STAFF REPORT

RE: 100 Grinnell Street

(permit application # T2021-0156 and T2021-0157)

FROM: Karen DeMaria, City of Key West Urban Forestry Manager

Photo showing location of trees along Grinnell Street.

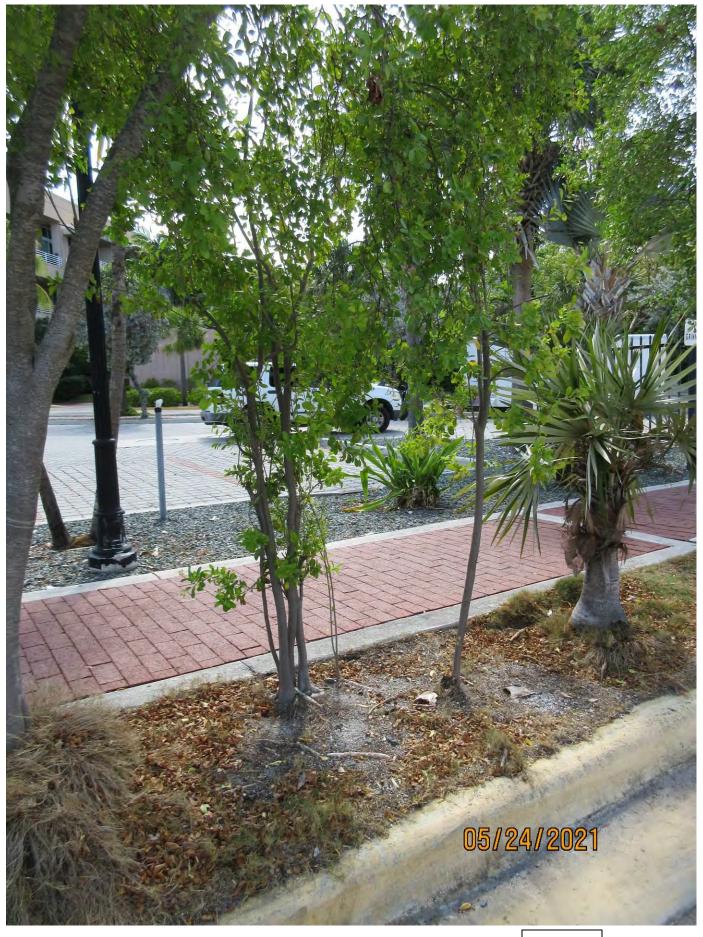
Tree #1-Diameter: 1.5"

Location: 80% (growing in center of sidewalk planter from root system of

mother tree, very visible)

Species: 100% (on protected tree list)

Condition: 70% (overall condition is good to fair. Young, single trunked

tree.)

Tree #2-Diameter: 2.5" (multi trunked)

Location: 70% (growing in sidewalk planter closer to edge, under canopy of

mother tree, growing from root system of mother tree, very visible.)

Species: 100% (on protected tree list)

Condition: 60% (overall condition is fair, multi trunked young tree, as tree grows there will be competition with trunks creating included bark. Visible girdled root across surface)

Standing on sidewalk, photo showing tree #7, view 1.

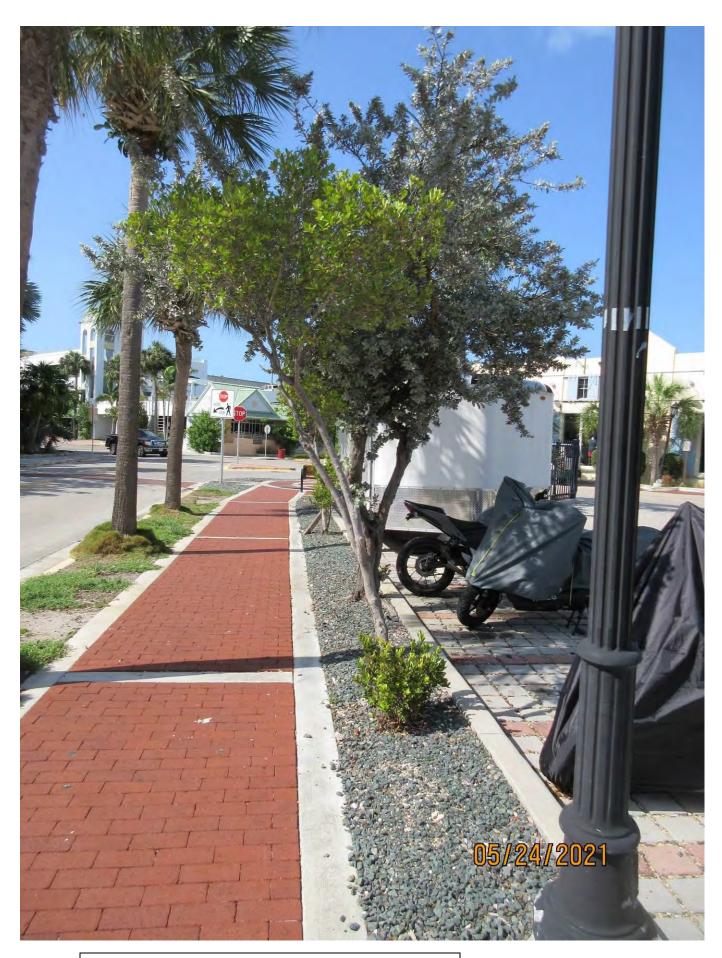
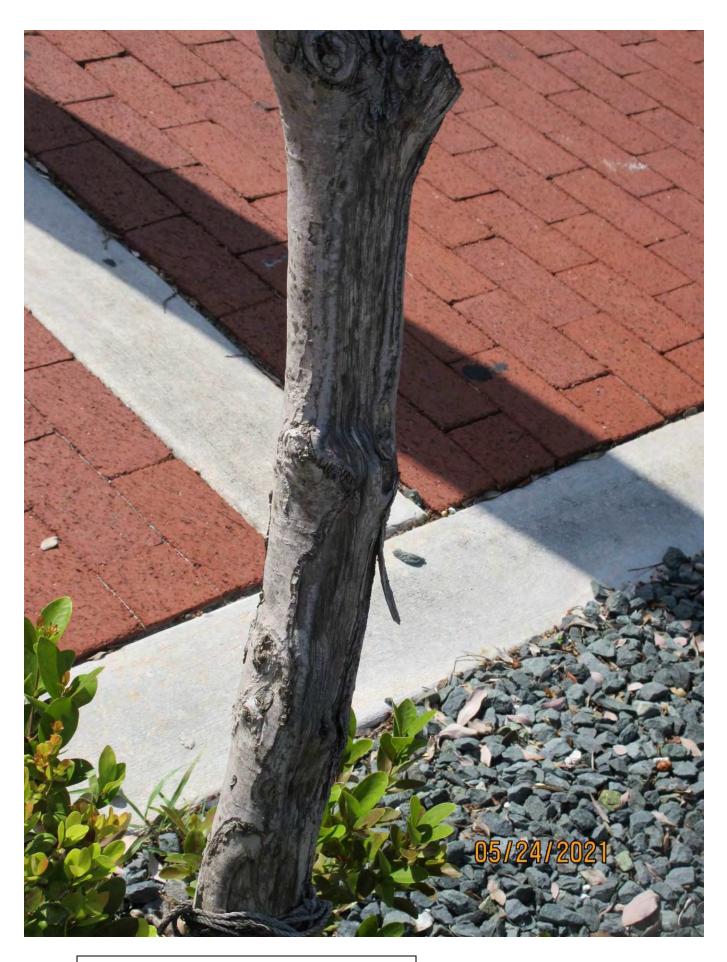
Tree #7-Diameter: 3.8"

Location: 80% (growing in sidewalk/parking planter, very visible tree.)

Species: 100% (on protected tree list)

Condition: 50% (overall condition is fair to poor. Tree heavily damaged during Hurricane Irma but is recovering, growth lean toward sidewalk)

Standing on sidewalk, photo showing tree #8, view 1.

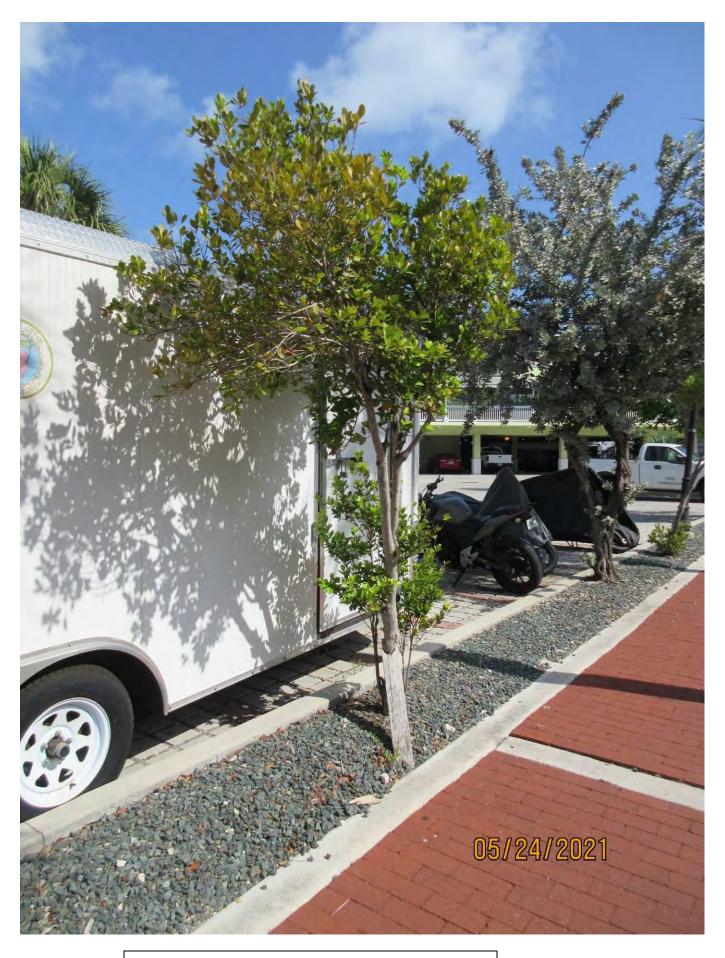
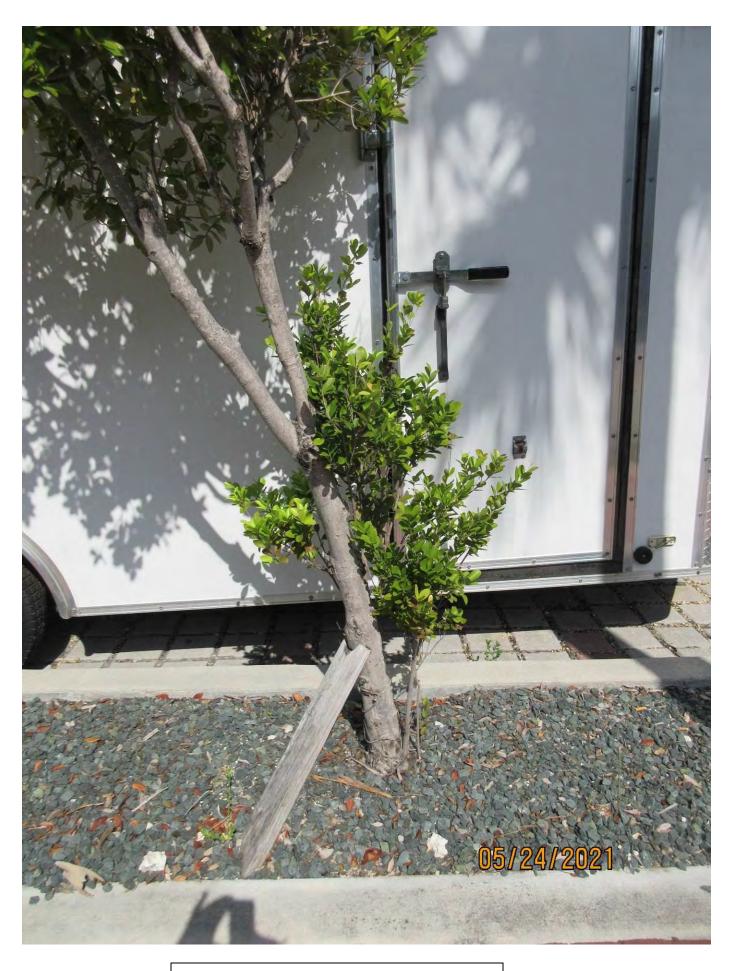
Tree #8-Diameter: 4.4"

Location: 80% (growing in sidewalk/parking planter. Very visible area.)

Species: 100% (on protected tree list)

Condition: 50% (overall condition is fair to poor, tree heavily damaged by

Hurricane Irma but us trying to recover.)

View of tree #5 from parking lot.

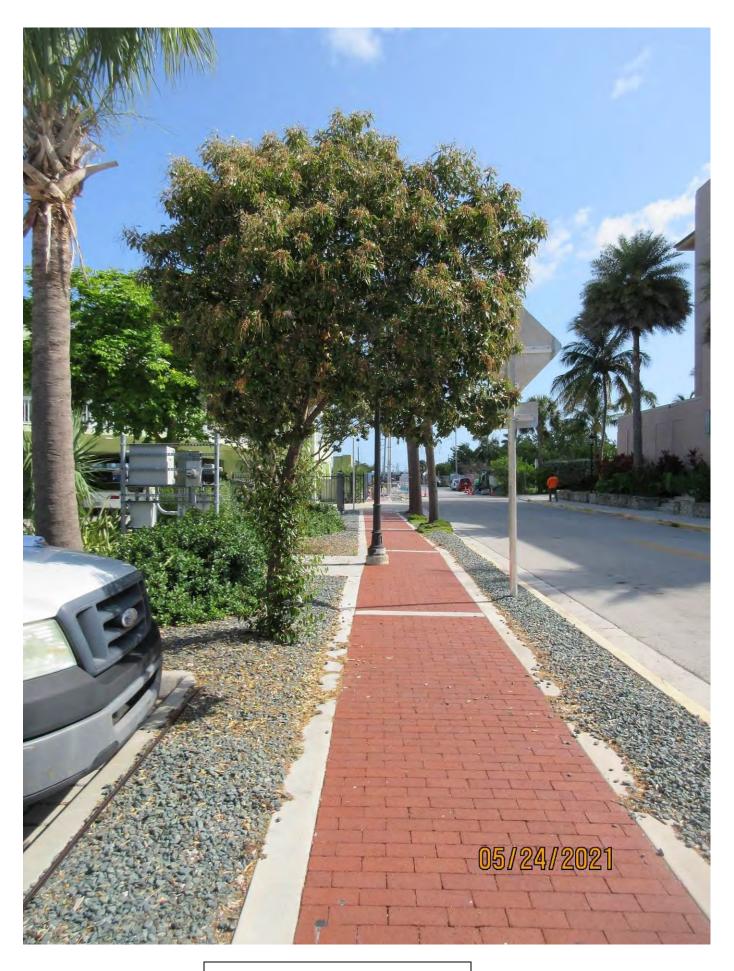
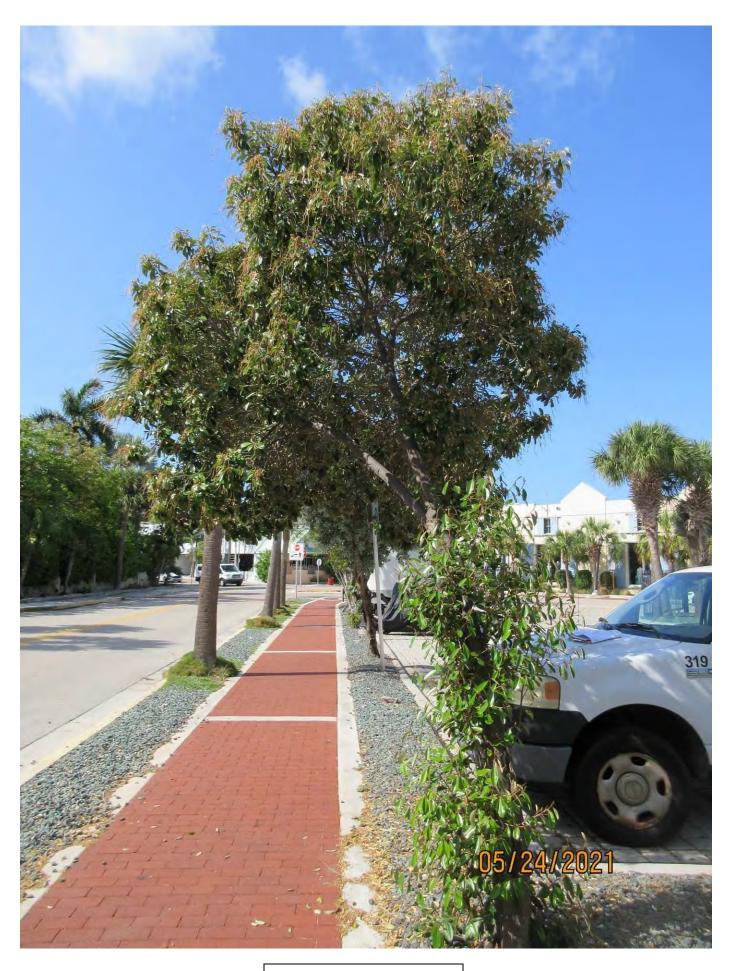
Diameter: 4.7"

Location: 70% (growing in sidewalk/parking planter, very visible tree.)

Species: 100% (on protected tree list)

Condition: 50% (overall condition is fair to poor, tree has growth lean

toward sidewalk, trunk damage from Hurricane Irma)
